SERVICE BULLETIN

Bulletin No. 001

Product: Model J Booster Heaters

Hairline Crack

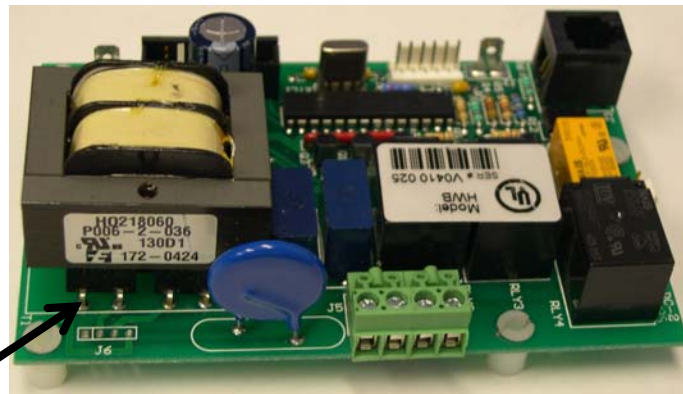
Background: The transformer located on the T1000 control board can develop a hairline crack in the left hand corner solder joint (see photo). This prevents power from being supplied to the display module, resulting in the booster heater becoming inoperable.

Current Status: All new T1000 control boards have an improved transformer mounting. Additionally, all circuit boards now utilize a rubber grommet and stand-off.

Remarks/Action: The transformer solder joint can be repaired in the field by re-soldering the cracked joint. If repair can not be easily performed, then replace the T1000 and return the component to Hubbell.
